Statement

Product Name: LTE Cat 1 bis Module

Model Number: EG915U-LA

EG915U-LA has three versions as following. All versions share the same HW design, the difference is as following:

- PCB Layout changes

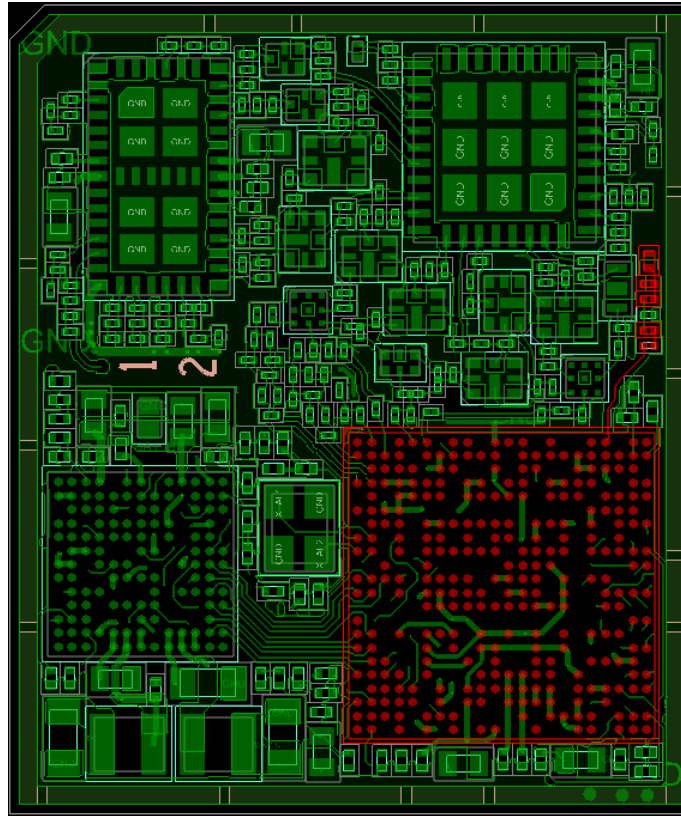
The change will not impact RF performance for the other frequency bands.
